SOARCA Peer Review DRAFT Comments

May 4, 2010

PEER REVIEW OF THE STATE-OF-THE-ART REACTOR CONSEQUENCE ANALYSIS (SOARCA) PROJECT

Figure 3 Typical Hazard Curve Taken From Figure 2-1 of ASCE Standard 43-05

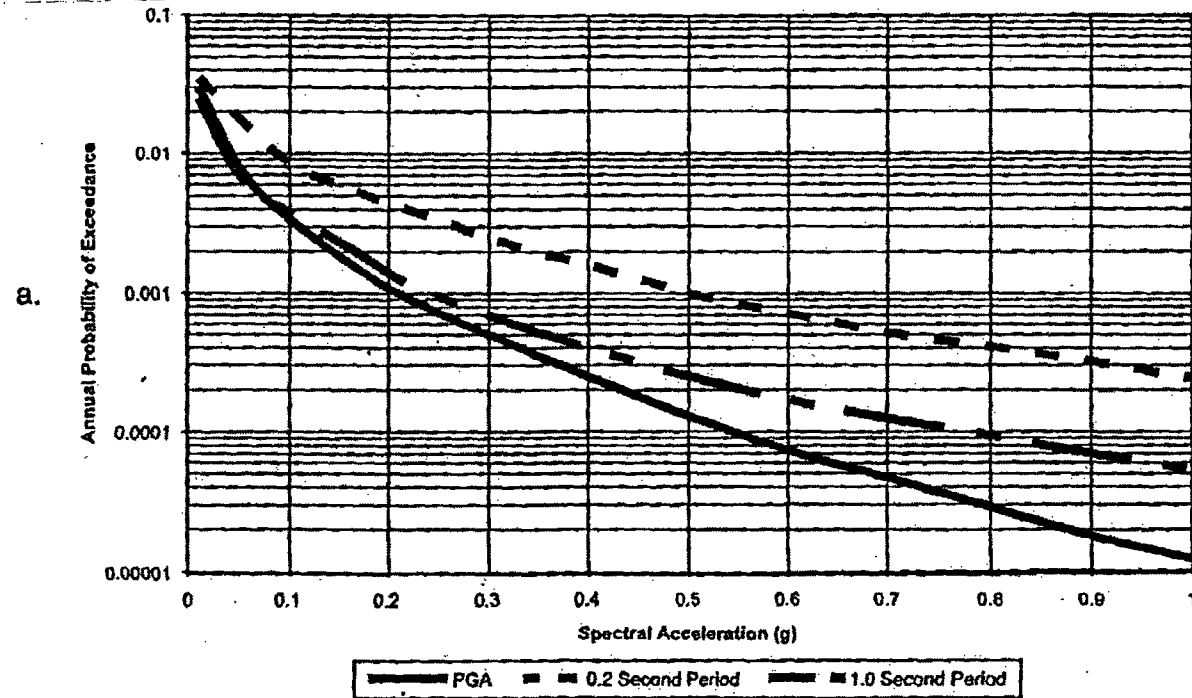
In Figure 3 is a summary of peak ground acceleration at median probability of exceedence at the 10^{-4} /yr level taken from a summary of median pga values developed during the NRC's IPEEE program. For the Surry site a value of about 0.24g pga for a mean, not median, 10^{-4} /yr probability of exceedence appears reasonable.

Figure
1

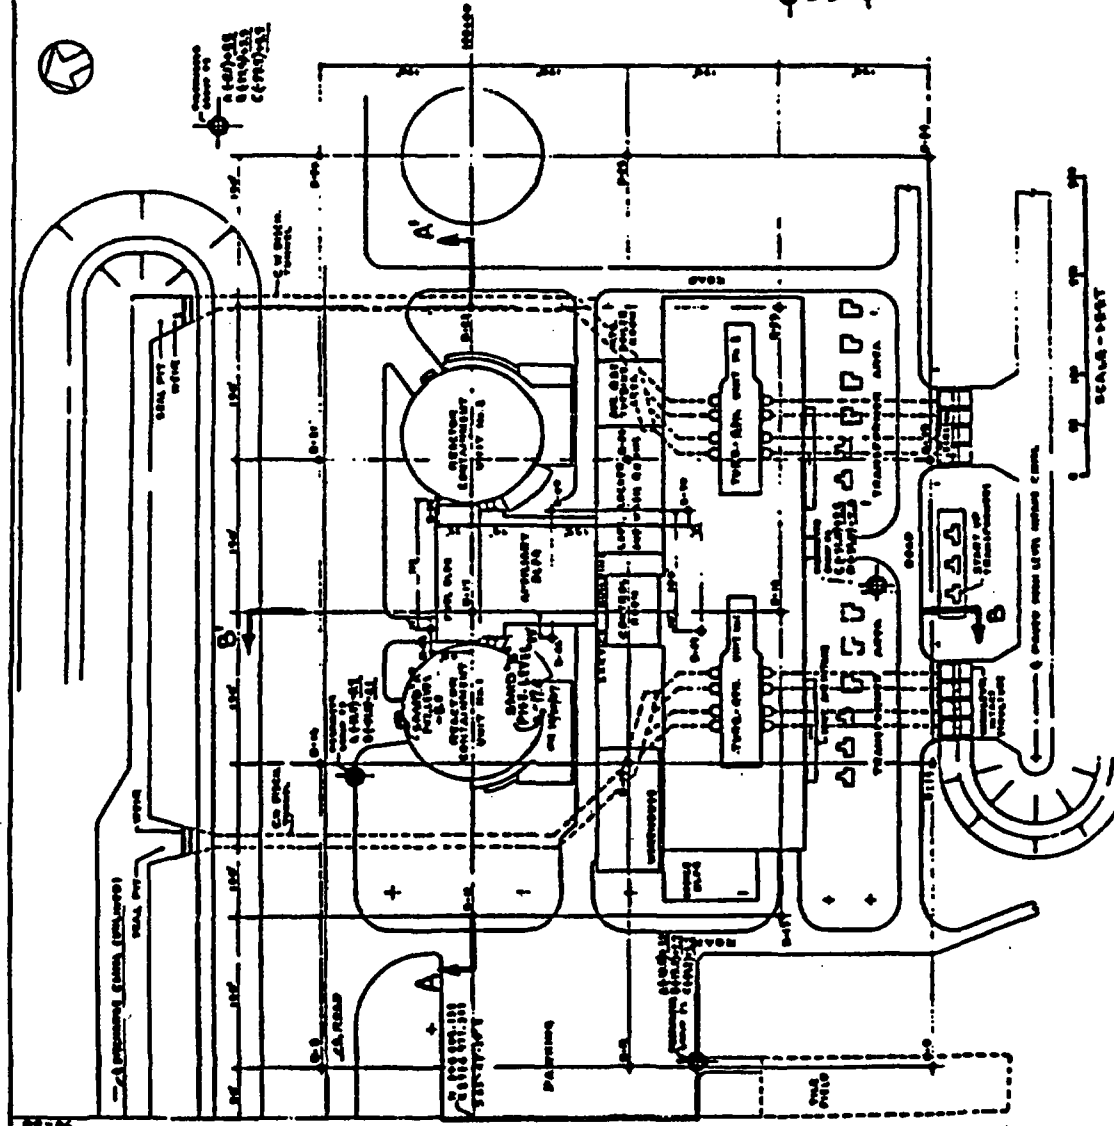
An assessment was also made of the potential for lateral movements of the structures toward the slope of the discharge canal (Figure 1) in the event of liquefaction. Simplified Newmark-type procedures as presented by Makdisi and Seed (1978) were utilized in estimating the deformations. It was assumed that the water level elevation in the canal was approximately equal to the ground water elevation. Based on these analyses, it is judged that lateral movements of the structures would be small (less than 1 inch) for levels of peak ground acceleration equal to or less than 1.5 times the accelerations required to cause liquefaction.
